Access Compliance Report Public Rights-of-Way (Curb Ramps)

Main Street: MCLEAN_DR Cross Street: BROWNING_AVE Location: N

ADA ID: RPRK211014132004 Ramp Type: Type 1 - Perpendicular Diagonal Initial Pass/Fail: Pass Overall Compliance: No Severity Score: 4

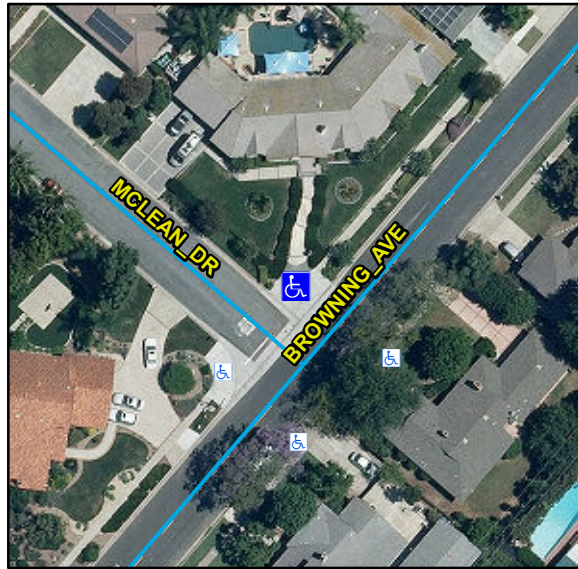
Remove & Replace Curb Ramp With Two New Directional Ramps or Equivalent. Remove & Replace Gutter.

R304.2.2, R304.2.1, R304.5.3, STD 1115
